Public Meeting on EPRI TR 3002025288 Review Request for Additional Information

Discuss status of the review and request for additional information (ADAMS Accession No. ML24352A469) associated with the NRC review of EPRI TR 3002025288, “Enhanced Risk-Informed Categorization Methodology for Pressure Boundary Components.”

Figure 1 - CCDP Threshold Consequence Chart

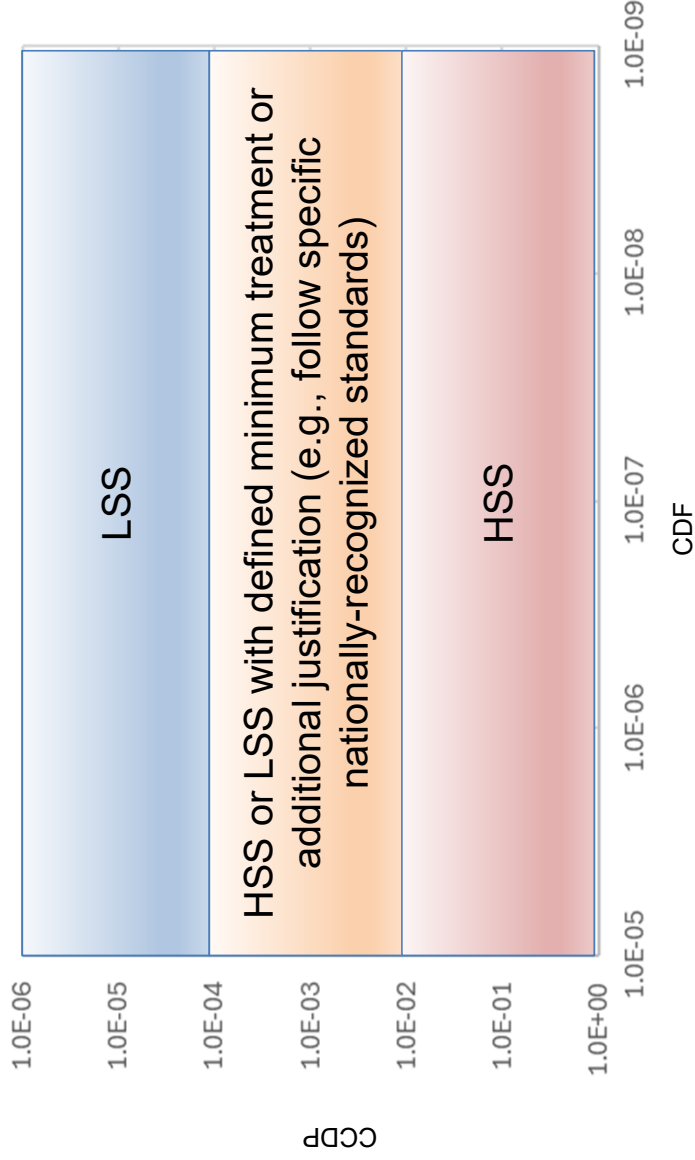
The audit found many SSCs with internal flooding CCDPs $>1 \times 10^{-4}$ and $<1 \times 10^{-2}$

Using CCDP instead of CDF×CCDP has many advantages:

- No change expected due to treatment or operating experience
- Lower uncertainty

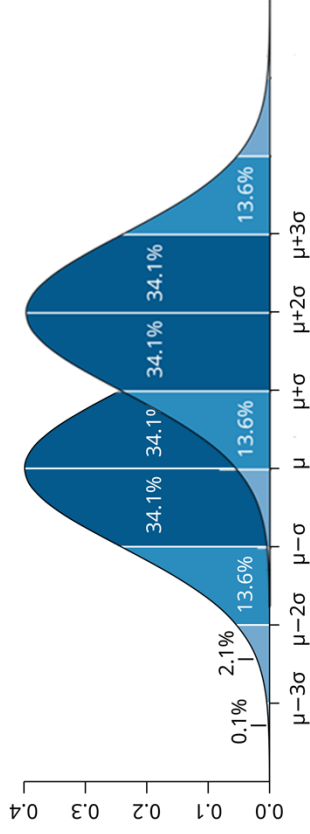
By categorizing only passive components in each system, it could create a situation where the alternative treatment for a passive LSS SSC adversely affects an active function/SSC.

Potential impacts on active system categorization should be **explicitly addressed**:

- ✓ To maintain level of reliability of the entire SSC per 10 CFR 50.69(c)(1)(iv) and 50.69(e)(3).
- ✓ Reasonable confidence that RISC-3 SSCs remain capable to performing their safety-related function per 10 CFR 50.69(d)(2).
- ✓ Consistent with active system categorization process in NEI 00-04.

UNCERTAINTY ANALYSIS (RAI-09)

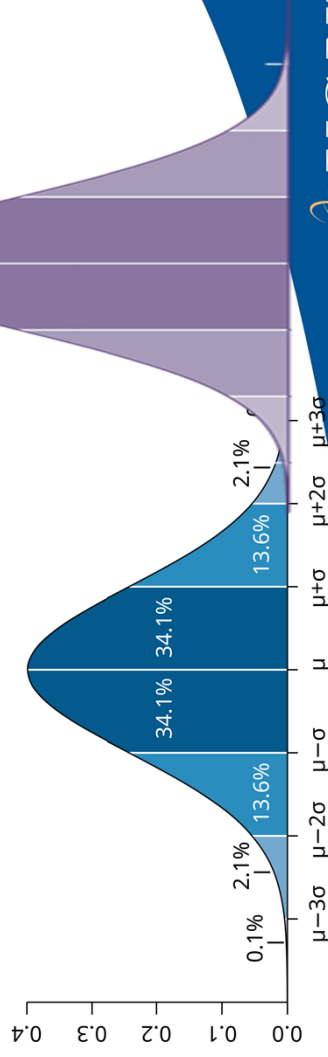
- Methodology relies on an uncertainty factor without sufficient evidence that the uncertainty factor is appropriate.
- Uncertainty factor used is appropriate to address “tail uncertainty,” whereas in methodology “distribution uncertainty” is paramount.

Tail Uncertainty
(proposed factor)

C&S compliant
pipe (Section III,
B31.1, etc.)

Component of
unknown reliability
and no minimum
treatment

Distribution Uncertainty
(proposal reality)
